SAN ANSELMO FLOOD RISK REDUCTION PROJECT

Final Environmental Impact Report
Volume 2 - Response to Comments
State Clearinghouse No. 2017042041

Prepared for
Marin County Flood Control and Water
Conservation District

Figure 3-13b
Water Surface Elevation Change With Project
10 - Year Flood Event: Upper San Anselmo

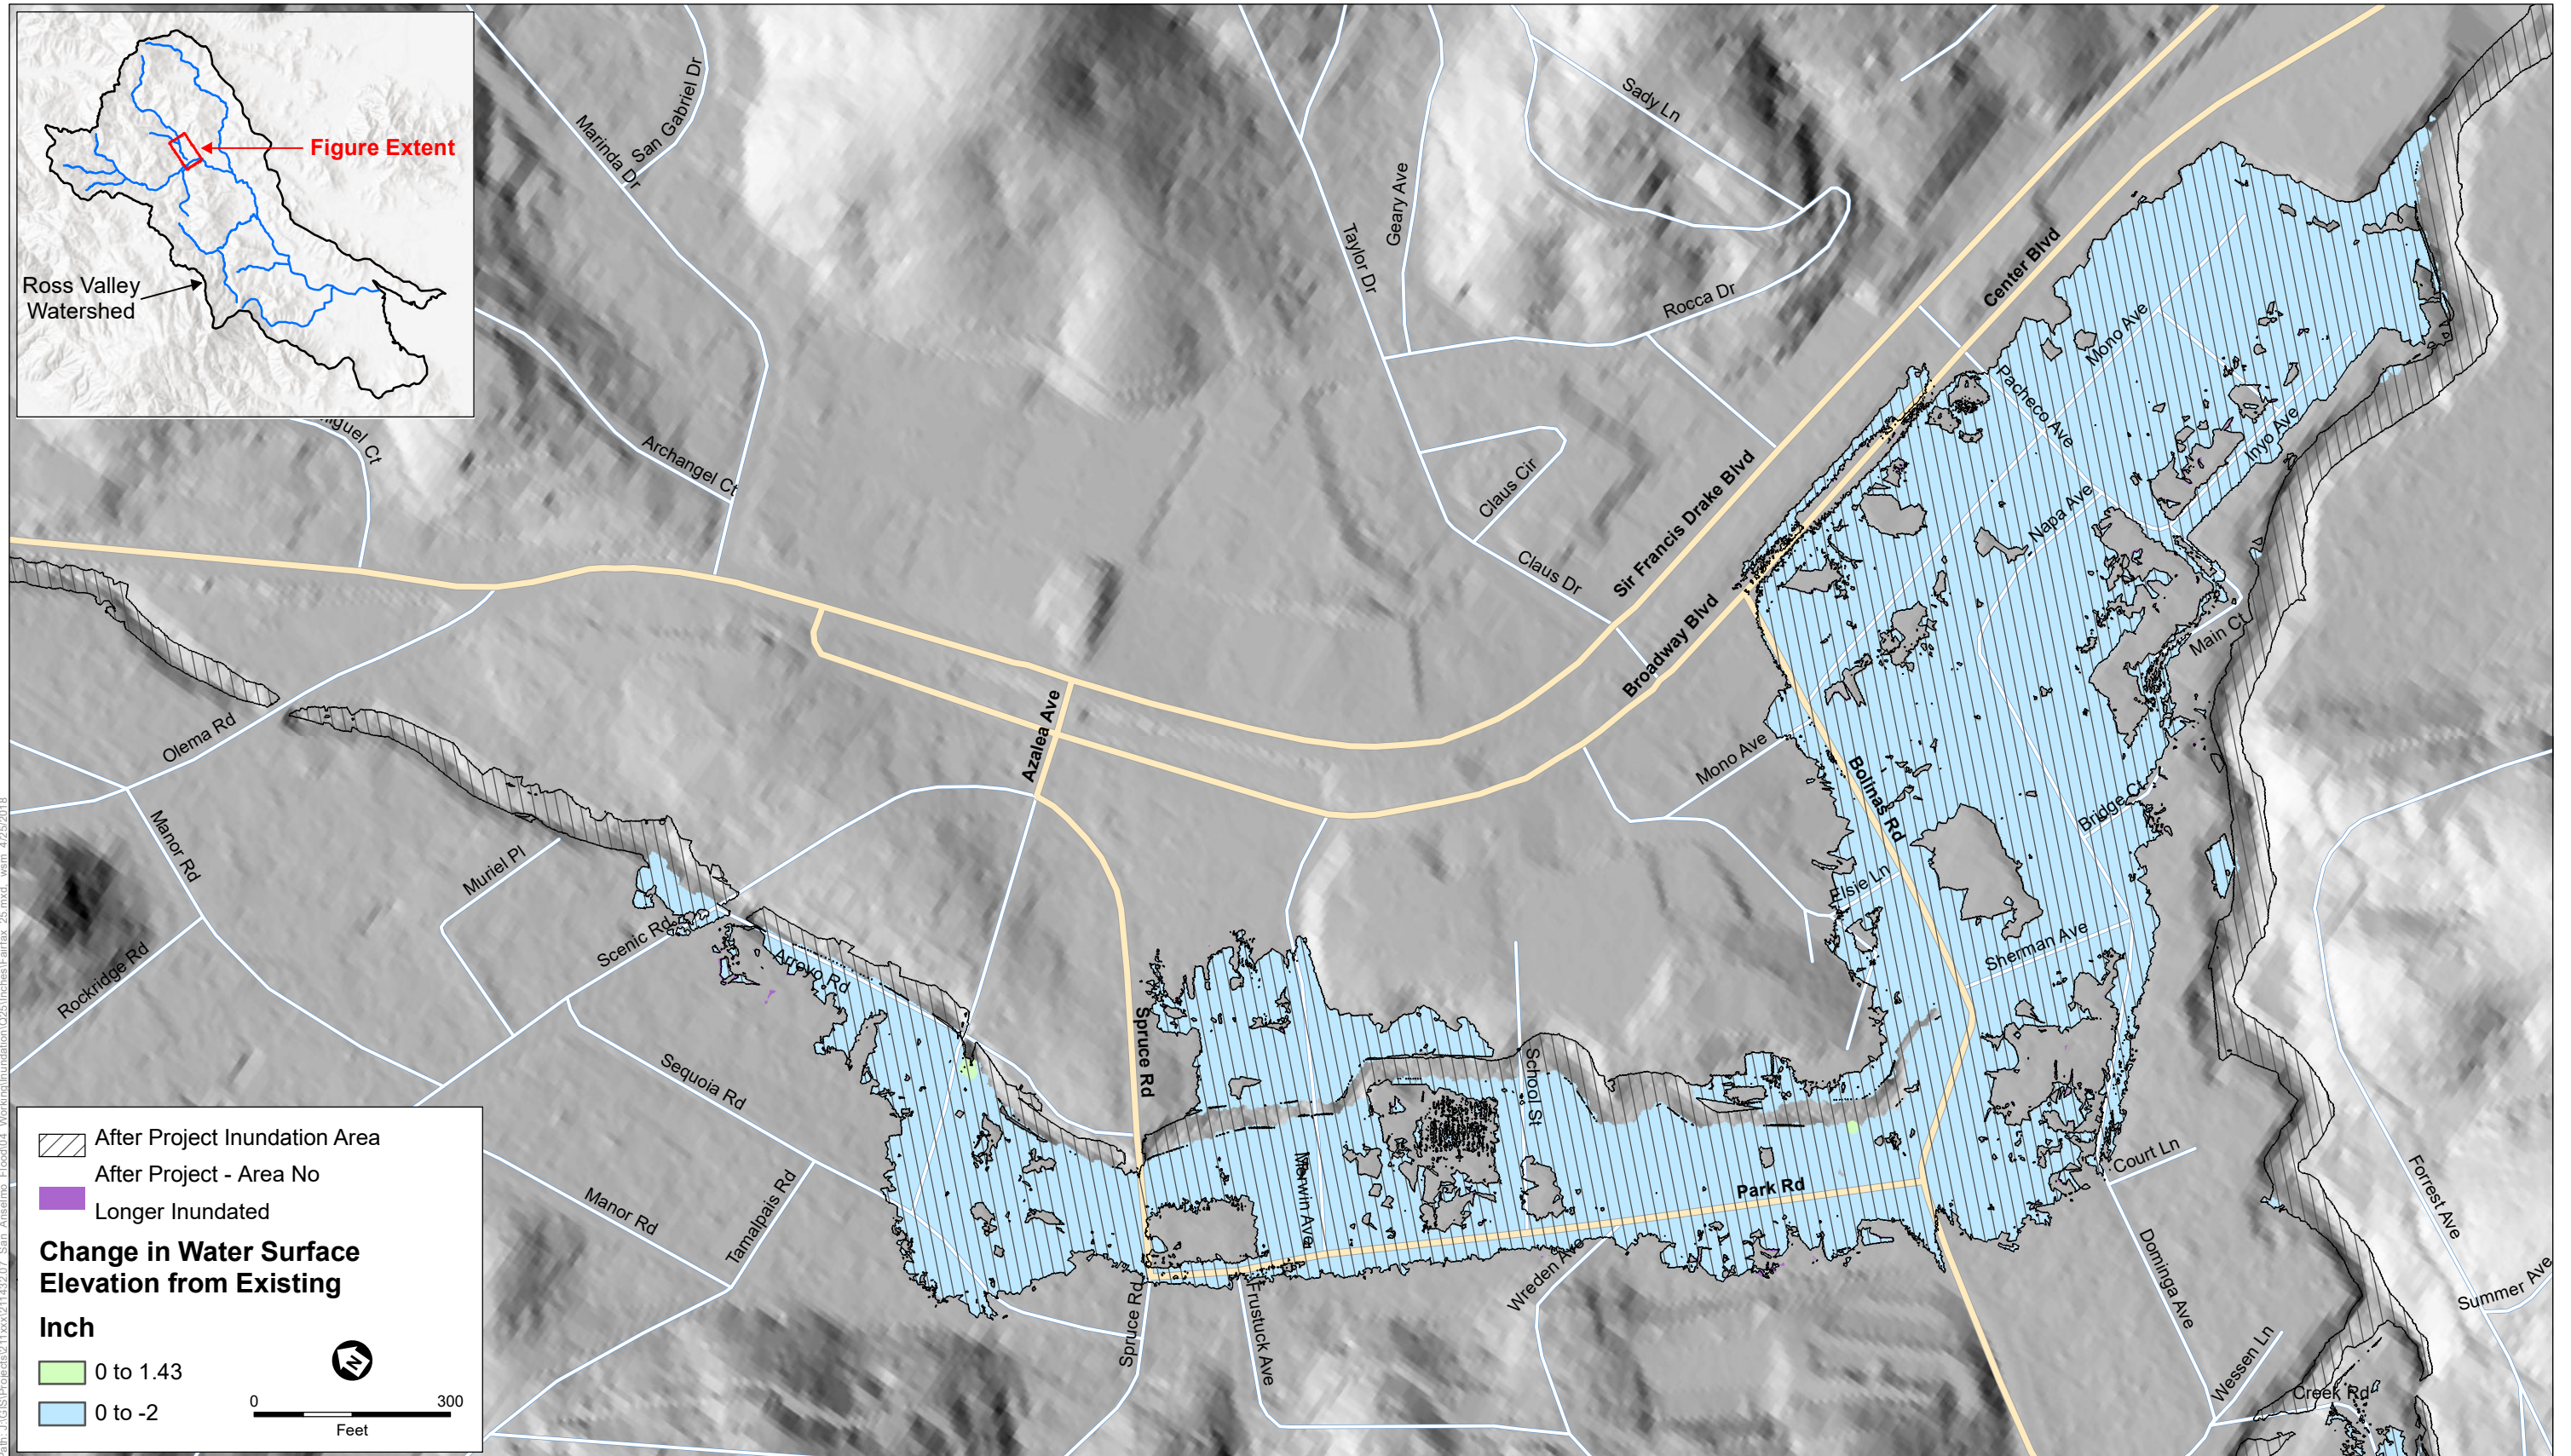
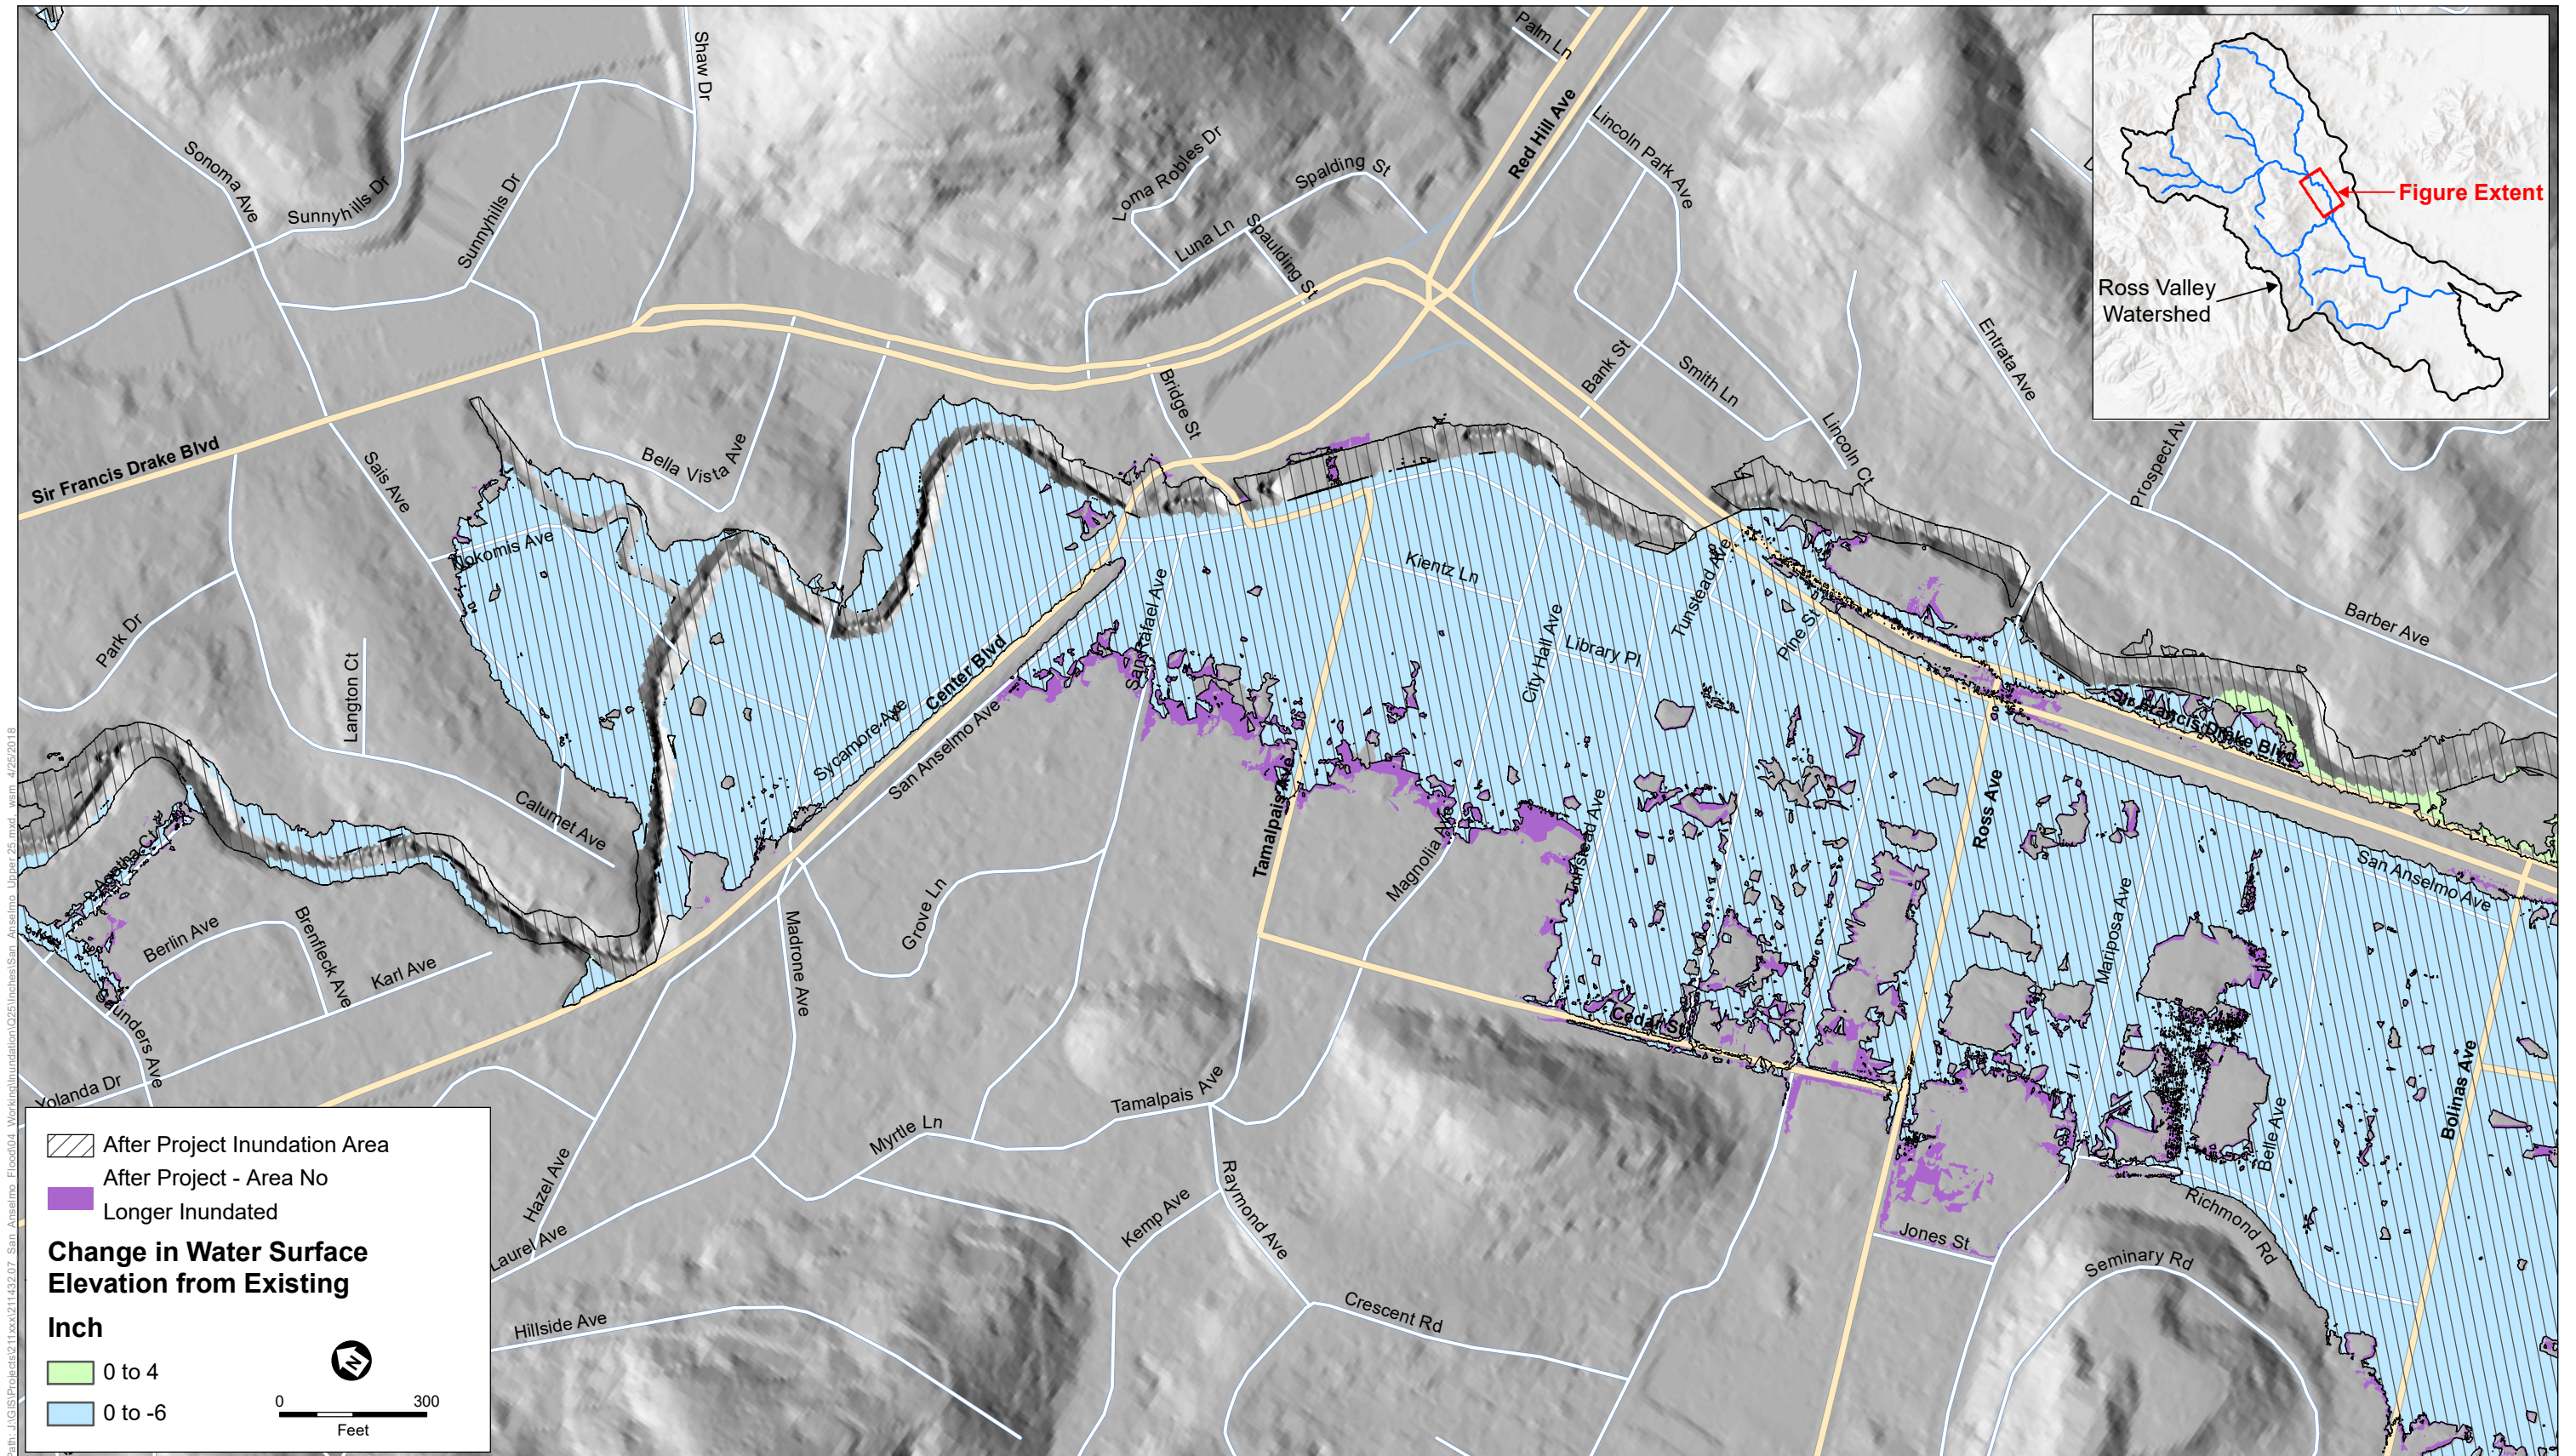
Figures in Chapter 3 (figures 3-13, 3-14, and 3-15), that show water surface elevation, change with project are not easy to interpret. It appears that the purple areas, labeled "After Project Inundation Reduction Area" would be removed from flooded areas during the specified events. However, use of the word "reduction" suggests that they would still be inundated, just to a lesser extent.

Draft EIR Figures 3-13a-c, 3-14a-c, and 3-15a-c have been revised in response to this comment. The revisions to these figures do not result in any changes to the environmental analysis in the Draft EIR.

In response to Comments B1-5 and PH-2, the legend descriptions associated with purple areas of Draft EIR Figures 3-13a-c, 3-14a-c, and 3-15a-c (Draft EIR pages 3-25 through 3-33) have been revised to read:

After Project ~~Inundation Reduction Area~~ – Area No Longer Inundated
